# UNITED STATES PATENT AND TRADEMARK OFFICE

APPLICATION NO.	FILING DATE	FIRST NAMED INVENTOR	ATTORNEY DOCKET NO.	CONFIRMATION NO.
10/664,982	09/17/2003	David Chong Sook Lim	112055-0040P1	4640
24267 7590 08/10/2007 CESARI AND MCKENNA, LLP 88 BLACK FALCON AVENUE BOSTON, MA 02210			EXAMINER ANDUJAR, LEONARDO	
			ART UNIT 2826	PAPER NUMBER
			MAIL DATE 08/10/2007	DELIVERY MODE PAPER

<b>Office Action Summary</b>	<b>Application No.</b>	<b>Applicant(s)</b>	
	10/664,982	LIM ET AL.	
	<b>Examiner</b>	<b>Art Unit</b>	
	Leonardo Andújar	2826

## **DETAILED ACTION**

FIG. 9

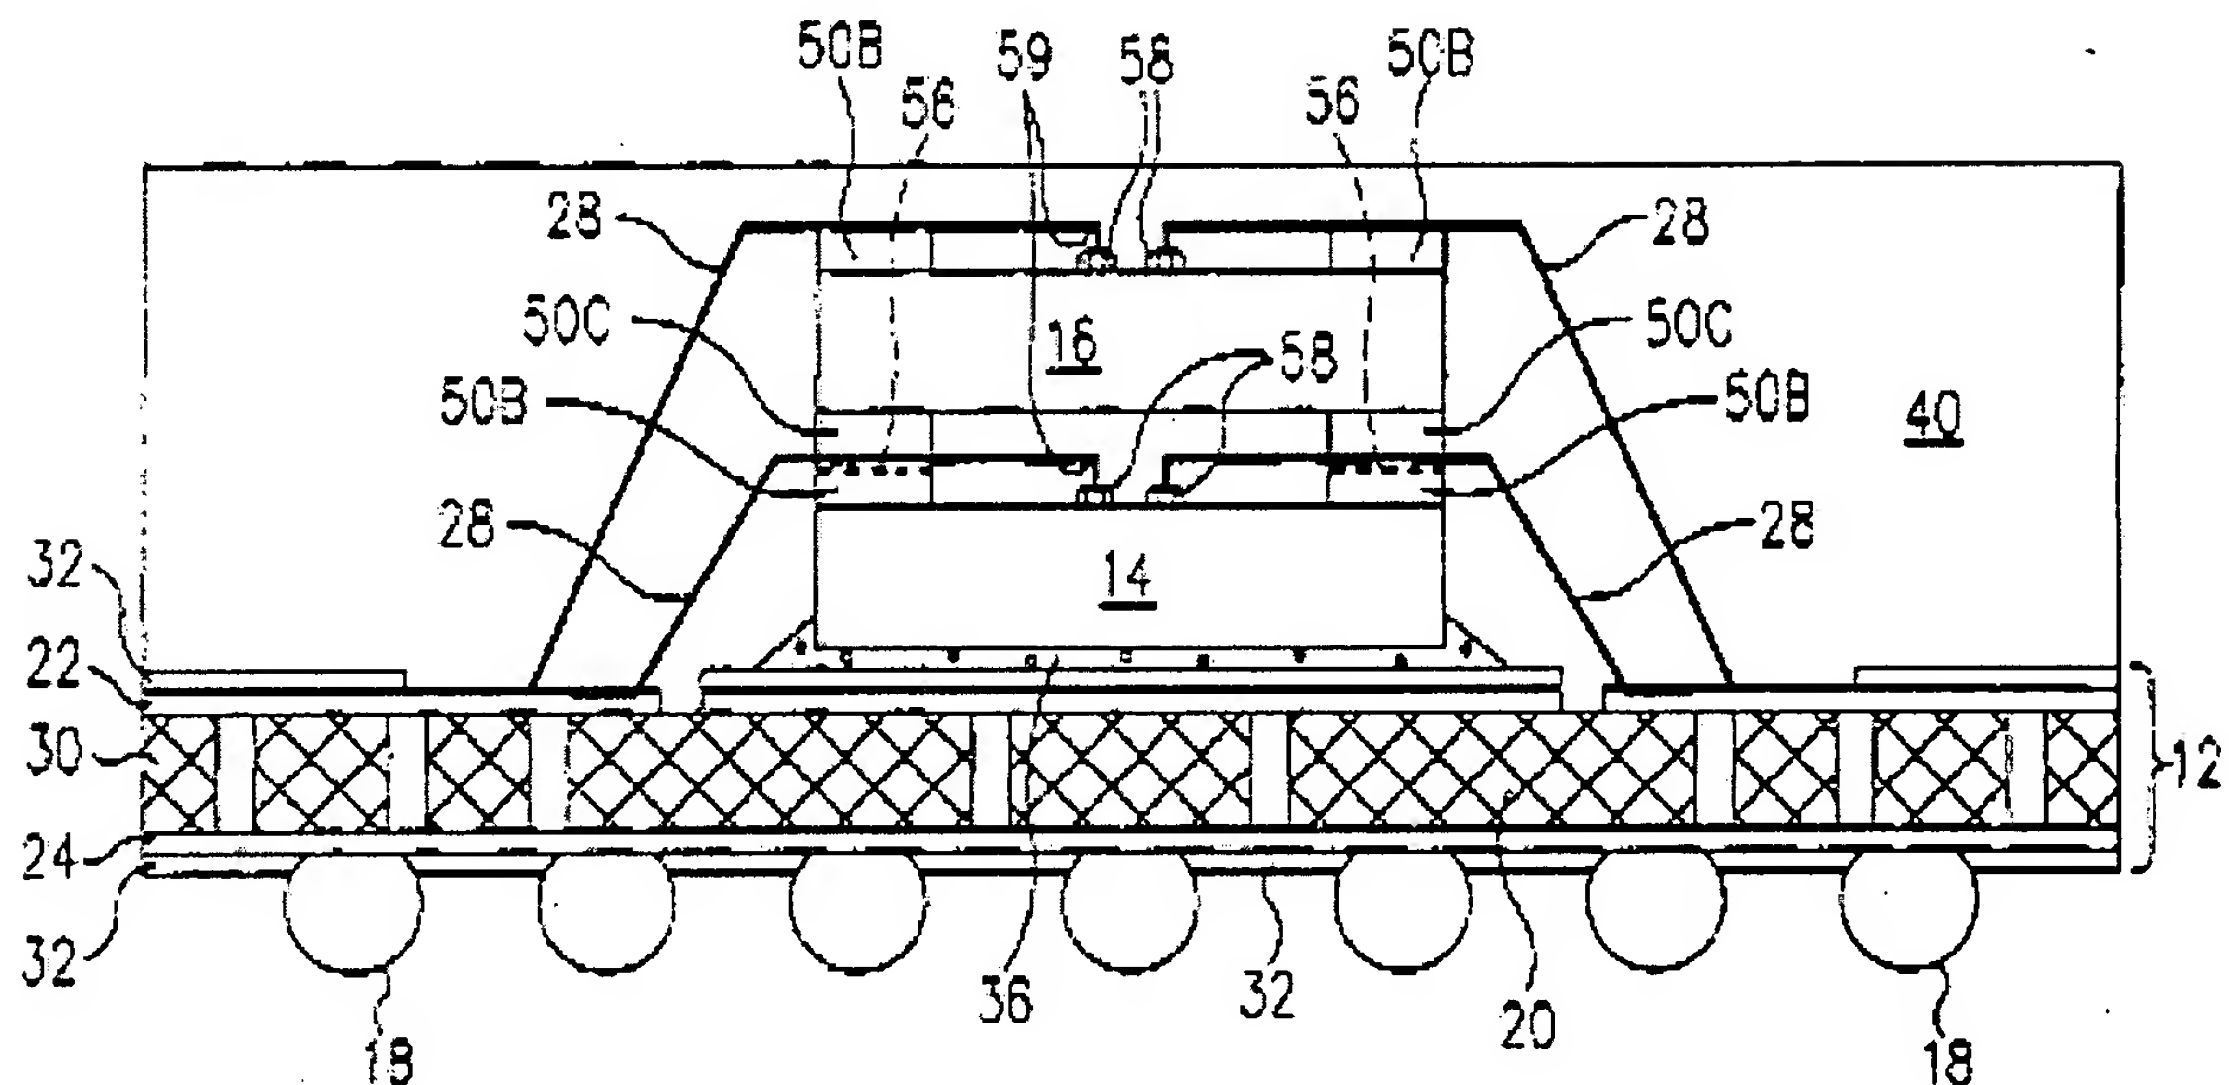
4. Regarding claim 1, Shim (e.g. figs. 9 & 5) shows a die containing package comprising: a die 14 defining electrical die contacts 34, the die contacts arranged along a first and an opposite side of the die (i.e. left side from the geometrical center line and right side from the geometrical center line of the chip), a substrate 30 defining first substrate contacts 22, flattened electrical conductive balls 58 attached to the die contacts and making electrical connection thereto, electrical conductive runs 24 on the substrate that run substantially under the die connecting the first substrate contacts, wherein the first substrate contacts are located adjacent to the first side of the die, to second substrate contacts 22, wherein the second substrate contacts are located adjacent to the opposite side of the die, electrically conductive wires 28 with first ends making electrical connections to the first substrate contacts, wherein the wires are

formed to run substantially parallel to the surface of the die, and wherein the other ends are horizontally attached to the flattened balls.

Shim does not teach that other ends are horizontally attached to the flattened ball. Nevertheless, Kang (e.g. fig. 3) shows electrically conductive wires 38 that run substantially parallel to the surface of the die and have ends that are horizontally attached to flattened balls 37. According to Kang, this type of connection minimizes a space between the first chip and a second chip, thereby reducing the total height of the semiconductor stack (abstract).

6. Regarding claim 5, Shim (e.g. fig. 9) shows process for packaging a die comprising the steps of: defining electrical die contacts, the electrical die contacts arranged along a first and an opposite side of the die (i.e. left side from the geometrical center line and right side from the geometrical center line of the chip), defining a substrate 12 with first substrate contacts 22, flattening an electrical conductive balls 58, attaching the flattened electrically conductive balls to the die contacts, forming electrical conductive runs 22/24 on the substrate 12 that run substantially under the die connecting the first substrate contacts, wherein the first substrate contacts are located

adjacent to the first side of the die, to second substrate contacts 22 wherein the second substrate contacts are located adjacent to the opposite side of the die, connecting electrically conductive wires 28 to the first substrate contacts, running the electrically conductive wires substantially parallel to the surface of the die contacts and attaching the other ends of the wires to the flattened electrically conductive balls thereby making electrical connections therebetween and wherein the other ends remain substantially parallel to the surface of the die. Shim does not teach that other ends are horizontally attached to the flattened ball. Nevertheless, Kang (e.g. fig. 3) shows electrically conductive wires 38 that run substantially parallel to the surface of the die and have ends that are horizontally attached to flattened balls 37. According to Kang, this type of connection minimizes a space between the first chip and a second chip, thereby reducing the total height of the semiconductor stack (abstract). It would have been obvious to one of ordinary skill in the art at the time the invention was made to horizontally attach the other ends of the wires disclosed by Shim to the flattened balls in accordance to Kang's invention to minimize the space between the first and the second chip, thereby reducing the total height of the semiconductor stack.

9. Applicant argues that the prior art does not show "electrical conductive runs on the substrate that run substantially under the die connecting the first substrate contacts". Nonetheless, Shim (e.g. fig. 9) shows electrical conductive runs 24 on the substrate that run substantially under the die connecting the first and second substrate contacts 22. Note that the contacts 22 are connected by vias or plated holes. Arguments of counsel cannot take the place of factually supported objective evidence. See, e.g., *In re Huang*, 100 F.3d 135, 139-40, 40 USPQ2d 1685, 1689 (Fed. Cir. 1996); *In re De Blauwe*, 736 F.2d 699, 705, 222 USPQ 191, 196 (Fed. Cir. 1984).
